This shop drawing has been reviewed for conformance with the design concept and information given in the Contract Documents.

MEAD LUMBER
Woodside Ridge-Lot 159
Boise Cascade
N/A

File: Woodside Ridge-Lot 159

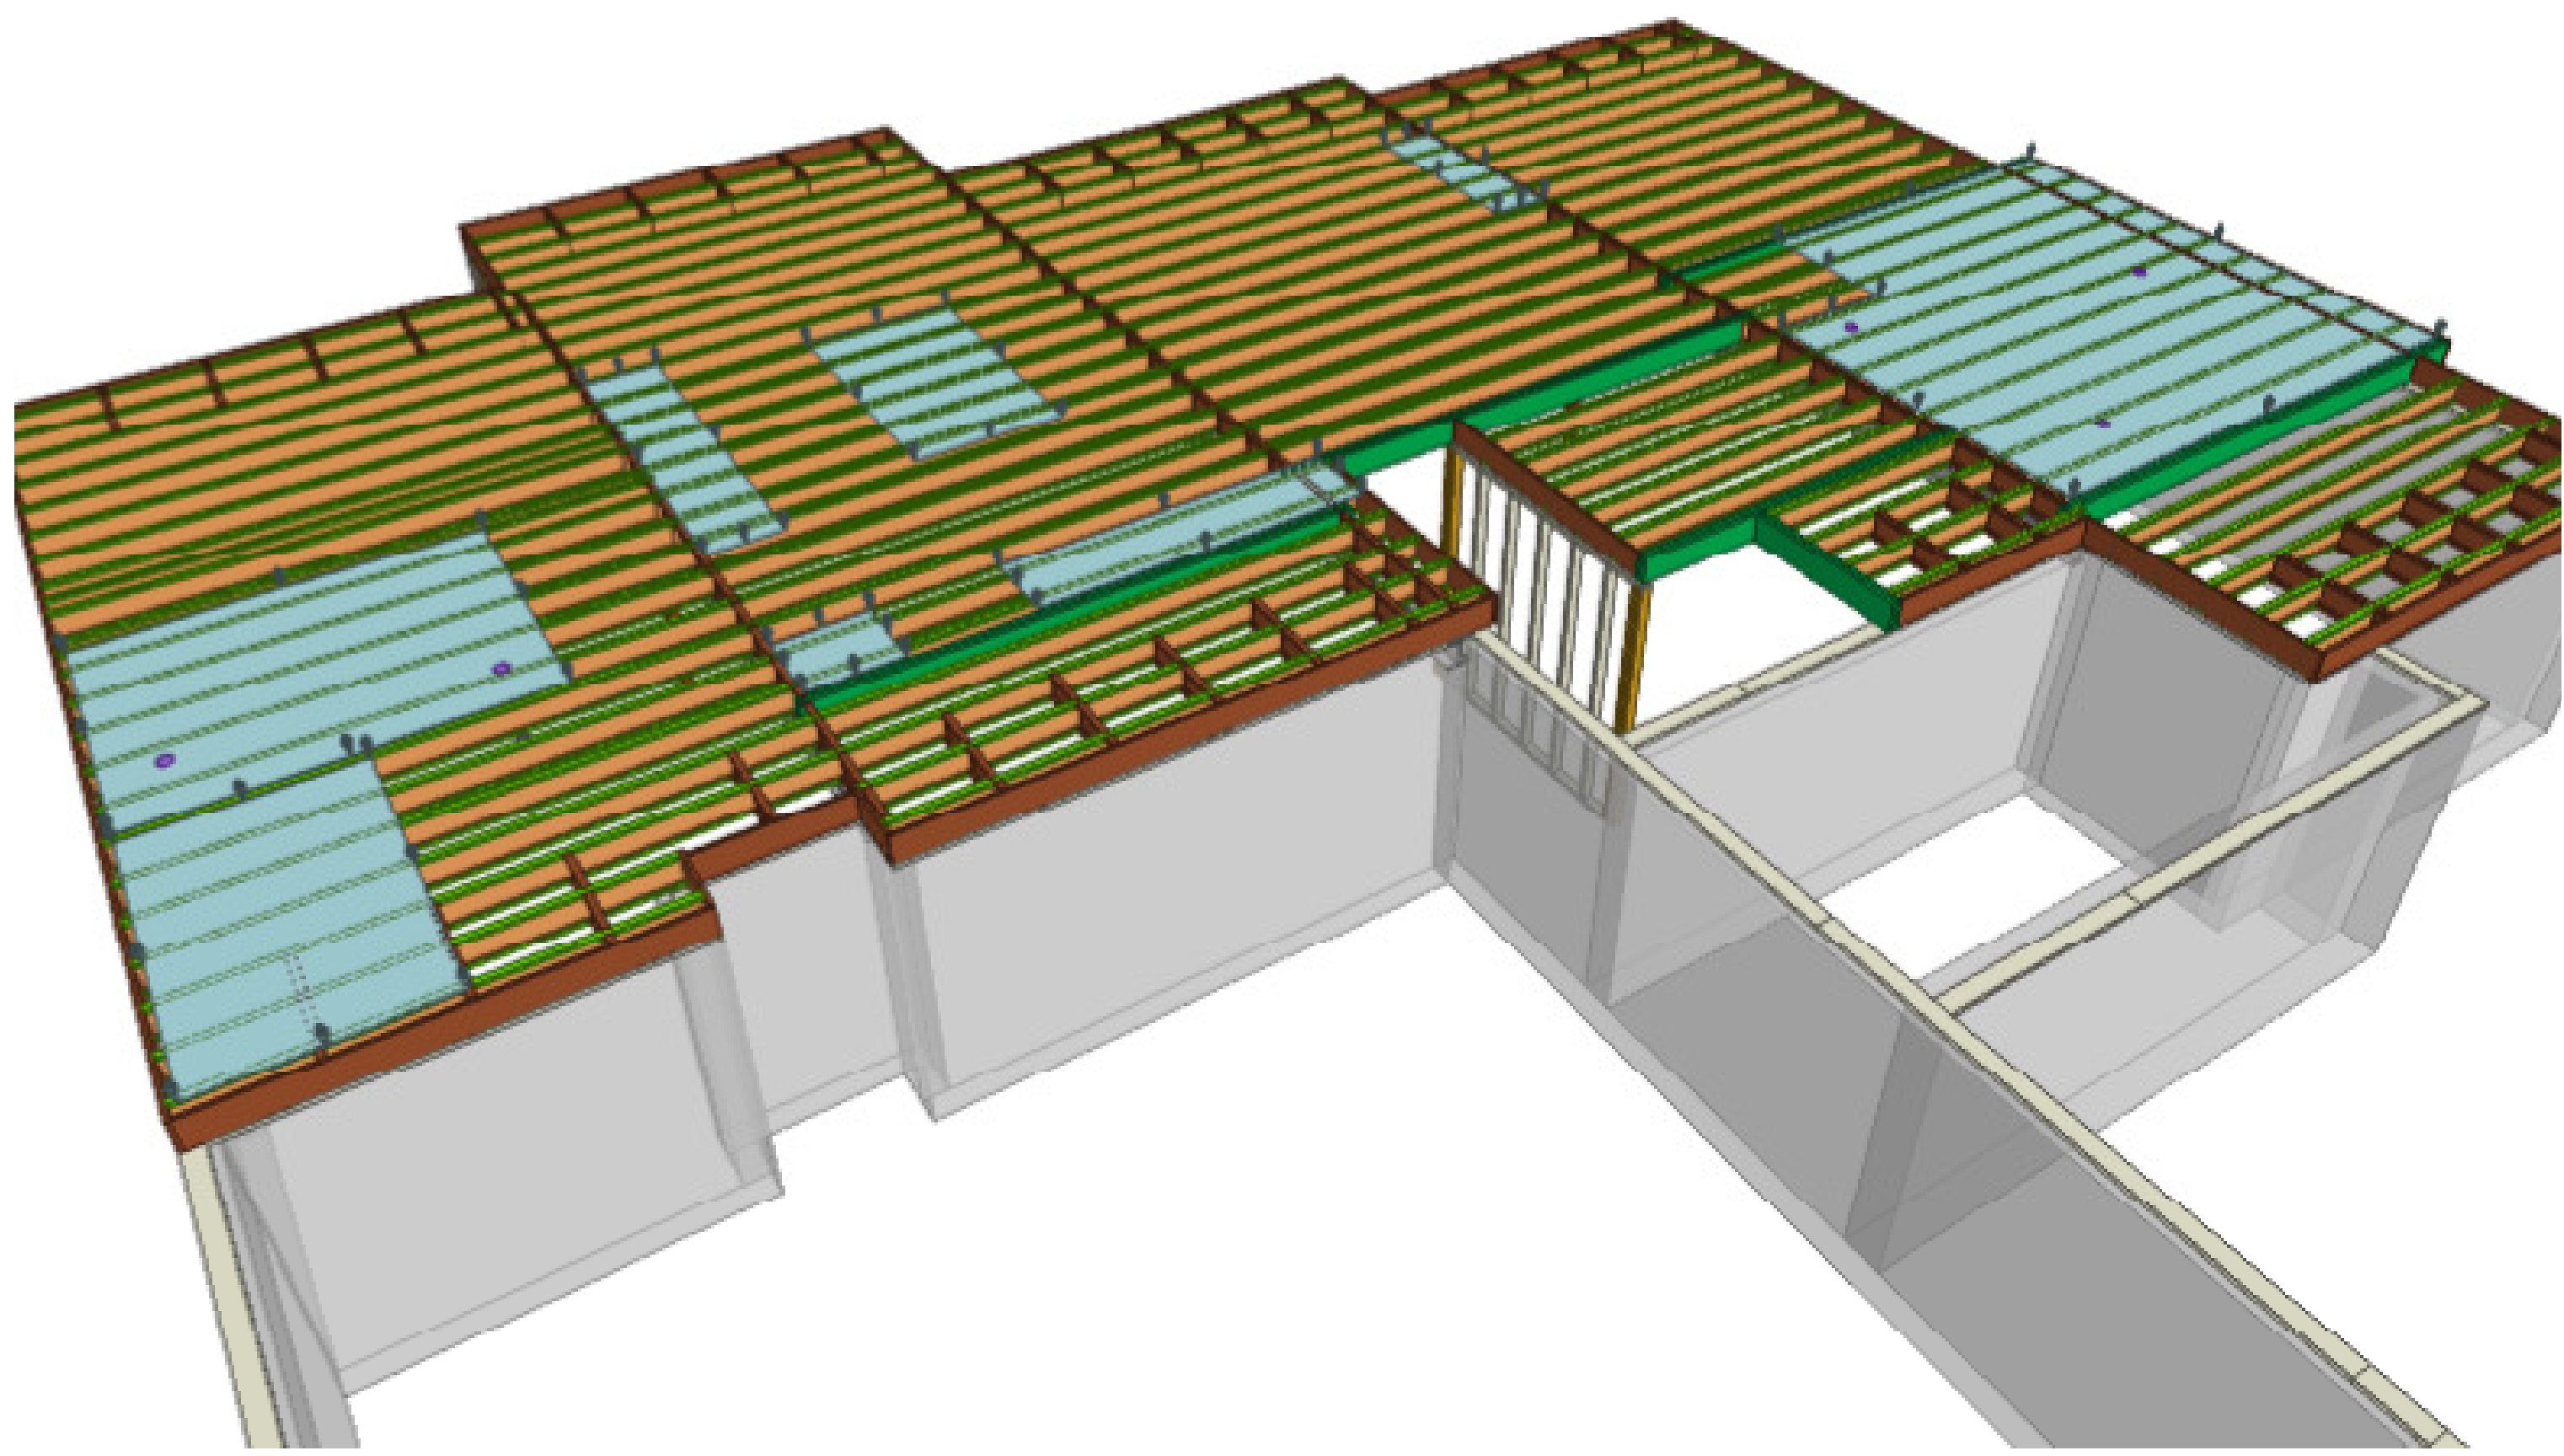
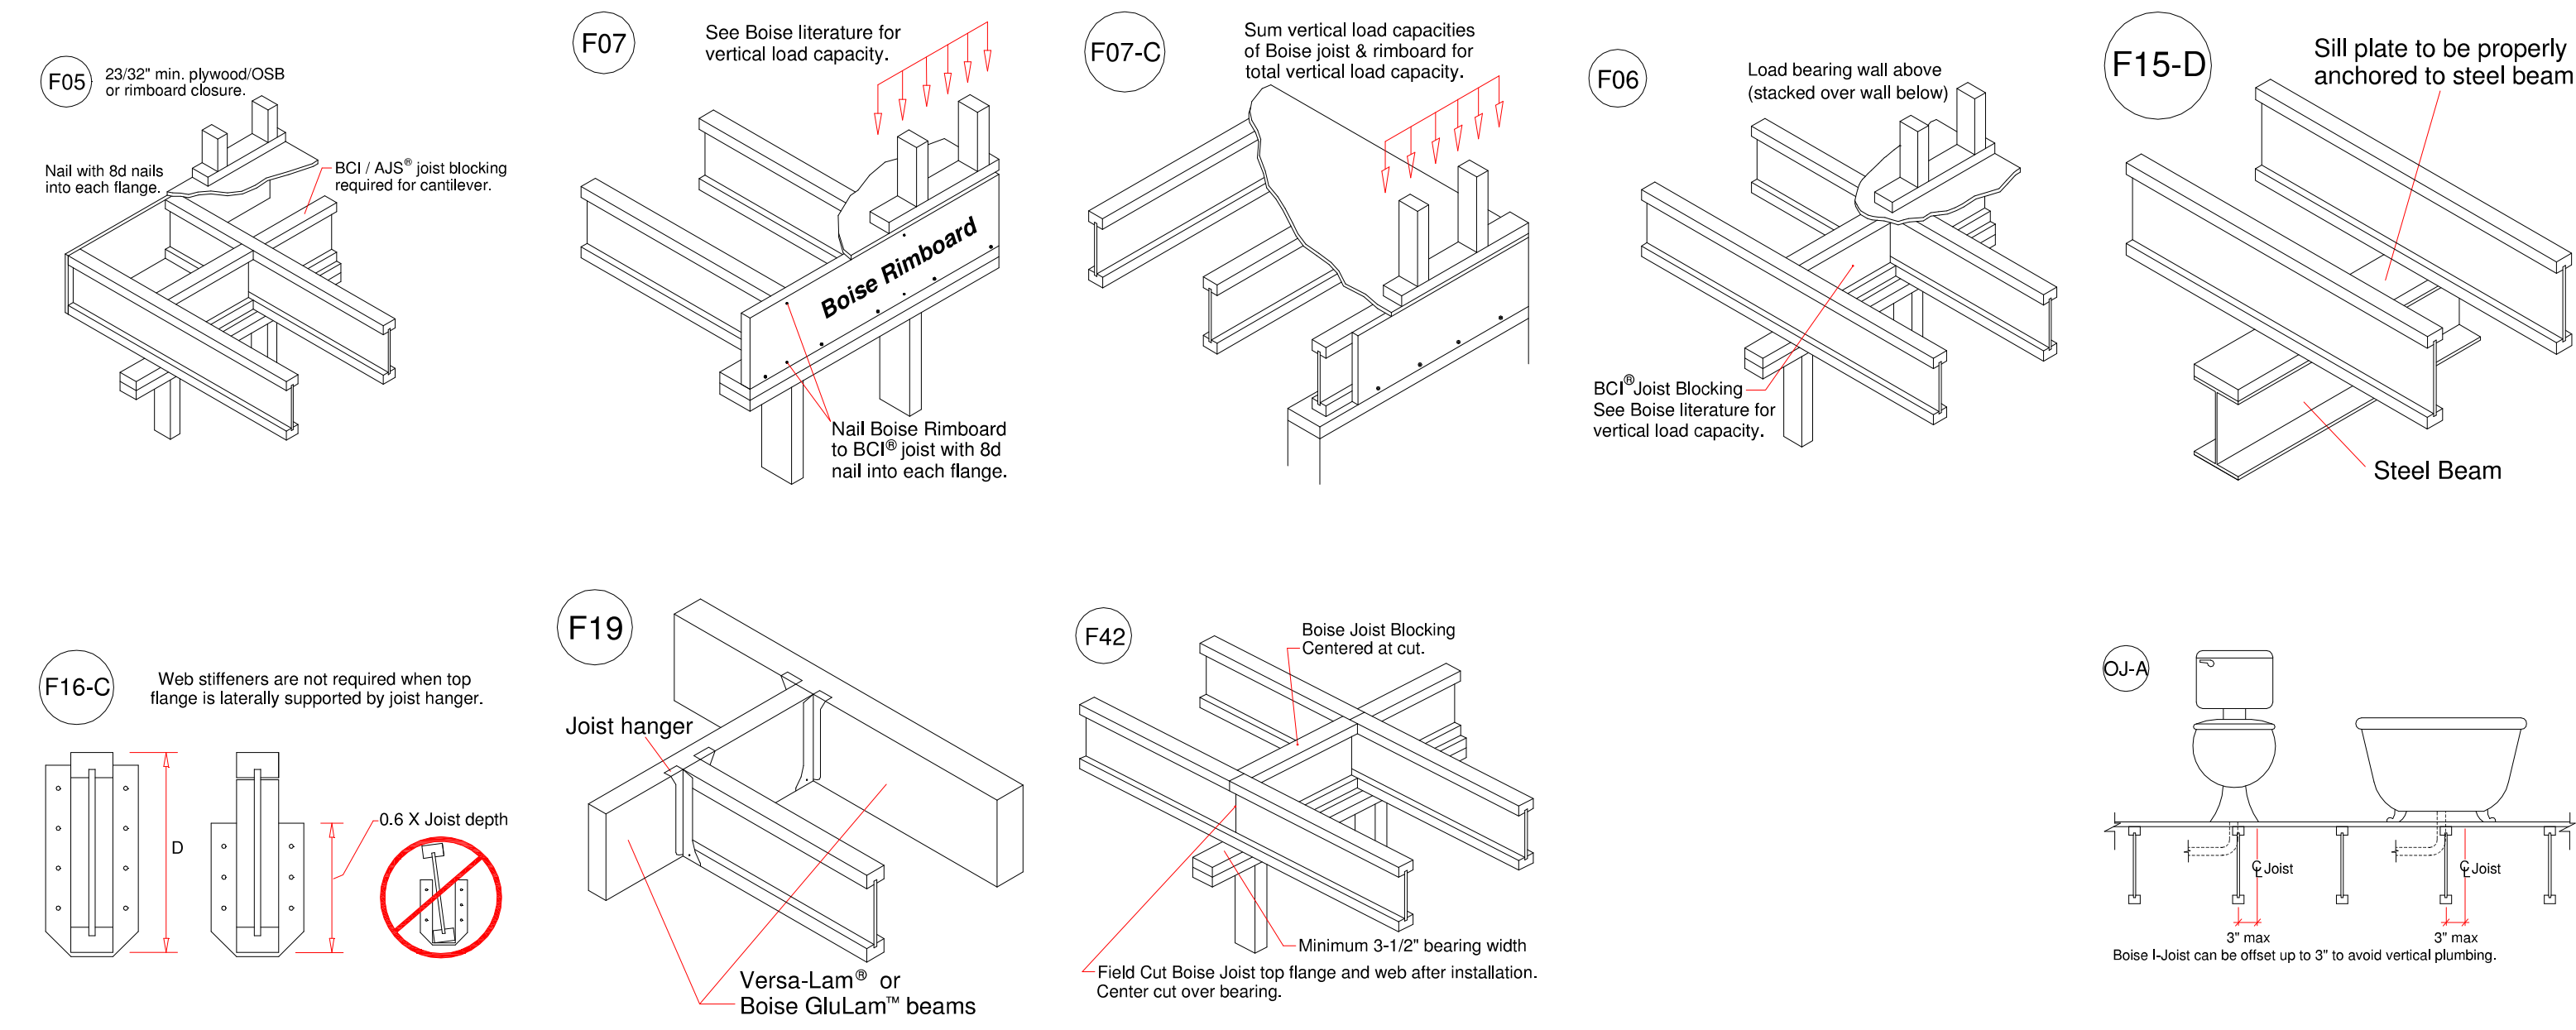
☒ Reviewed with no exceptions noted.
☐ Reviewed as noted.
☐ Returned for correction.
☐ Not Reviewed.
